SUBJECT: Forwards revised FSAR pages from Section 9.2.5 (ultimate heat sink). Pages will be incorporated into Amend 23 of facility FSAR.

Subject: NUCLEAR PROJECT NO. 2
REVISED FSAR PAGES TO SECTION 9.2.5

Enclosed are sixty (60) copies of revised FSAR pages from Section 9.2.5, Ultimate Heat Sink. These pages will be incorporated into Amendment 23 of the WNP-2 FSAR.

9.2.5 ULTIMATE HEAT SINK

Figure 9.2-5

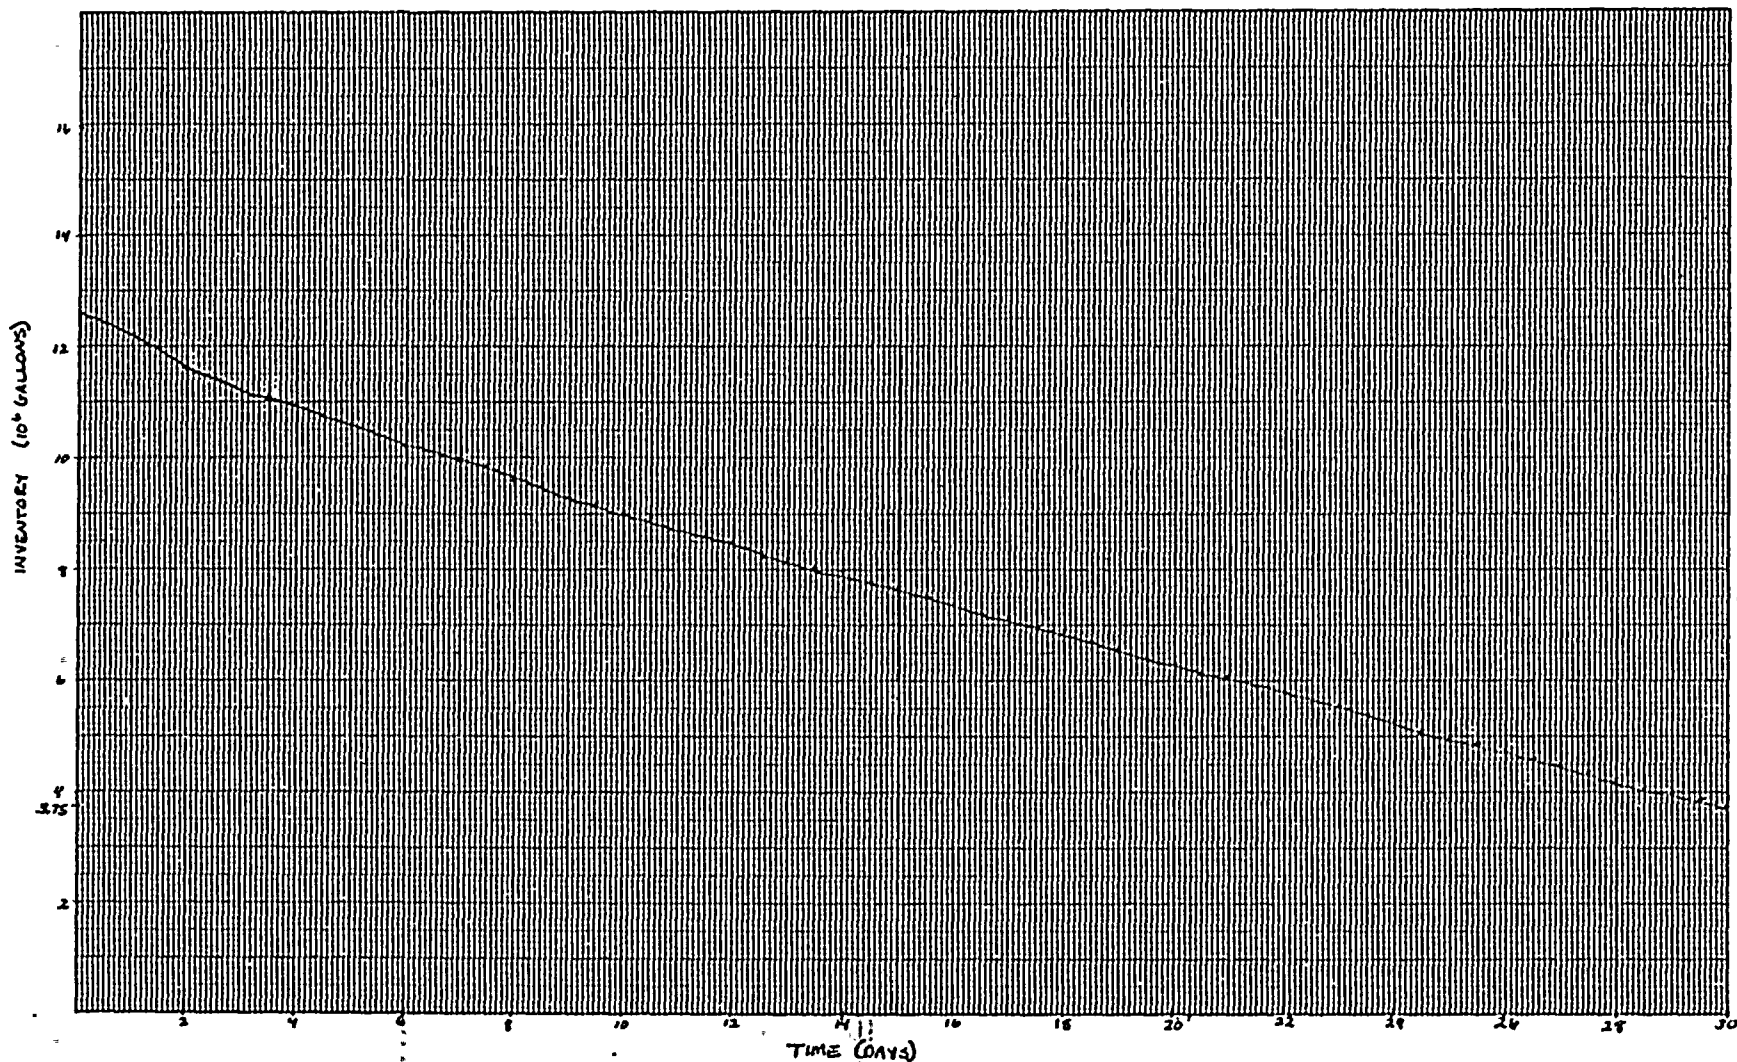
The results of the mass loss analysis assuming an unfouled heat exchanger is shown in Figure 9.2-8 and is tabulated in Table 9.2-3. The mass loss assuming a fouled heat exchanger is less severe, but only by approximately 2,000 gallons.
